UNITED STATES
DEPARTMENT OF THE INTERIOR
BUREAU OF LAND MANAGEMENTFORM APPROVED
OMB NO. 1004-0137
Expires: January 31, 2018**SUNDRY NOTICES AND REPORTS ON WELLS**
Do not use this form for proposals to drill or to re-enter an abandoned well. Use form 3160-3 (APD) for such proposals.
Carlsbad Field Office
OCD Artesia5. Lease Serial No.
NMNM15291

8. Well Name and No.
HUBER FEDERAL 10H9. API Well No.
30-015-44848-00-X110. Field and Pool or Exploratory Area
SEVEN RIVERS11. County or Parish, State
Glorieta/yes 97565
EDDY COUNTY, NM.**SUBMIT IN TRIPLICATE - Other instructions on page 2**

TYPE OF SUBMISSION	TYPE OF ACTION			
☒ Notice of Intent	☐ Acidize	☐ Deepen	☐ Production (Start/Resume)	☐ Water Shut-Off
☐ Subsequent Report	☐ Alter Casing	☐ Hydraulic Fracturing	☐ Reclamation	☐ Well Integrity
☐ Final Abandonment Notice	☐ Casing Repair	☐ New Construction	☐ Recomplete	☒ Other
	☐ Change Plans	☐ Plug and Abandon	☐ Temporarily Abandon	Drilling Operations
	☐ Convert to Injection	☐ Plug Back	☐ Water Disposal

WELL LOCATION AND ACREAGE DEDICATION PLAT

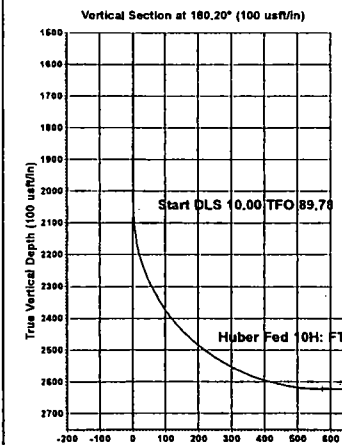
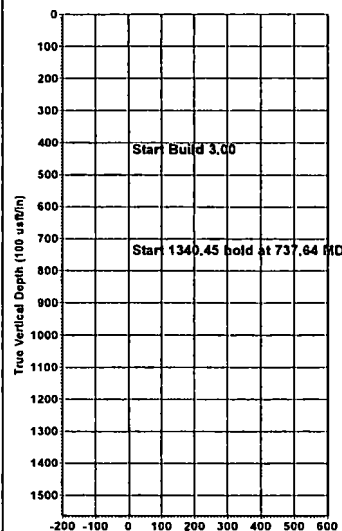
SHL has moved 40' east from 474' FSL & 2535' FWL to ~~474' FSL & 2575' FWL~~. No change in pad size.BHL has moved 334' east from 20' FSL & 2571' FWL to ~~20' FSL & 2375' FWL~~. (See attached C102.)

UL or lot No.	Section	Township	Range	Lot Idn	FEET from the	North/South line	FEET from the	East/West line	County
N	34	19 S	25 E		474	SOUTH	2575	WEST	EDDY

UL or lot No.	Section	Township	Range	Lot Idn	FEET from the	North/South line	FEET from the	East/West line	County
N	3	20 S	25 E		20	SOUTH	2375	EAST	EDDY

Company: Percussion Petroleum, LLC
Project: Eddy County, NM
Site: Huber Fed
Well: 10H
Wellbore: OH
Rig: Silver Oak 1
Design: Plan #4 / 10:55, June 13 2018

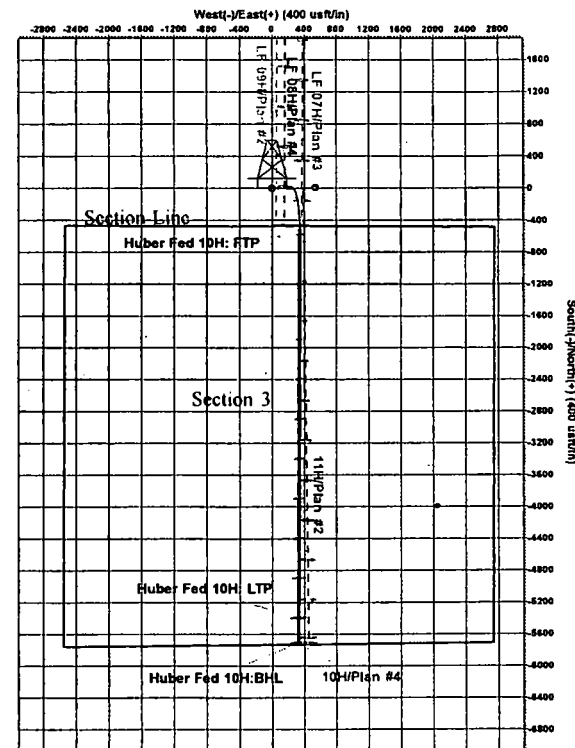
TVD has changed from 2571' to 2623'. ✓

MD has changed from 8035' to 8112'. (See attached well bore views & plans.)
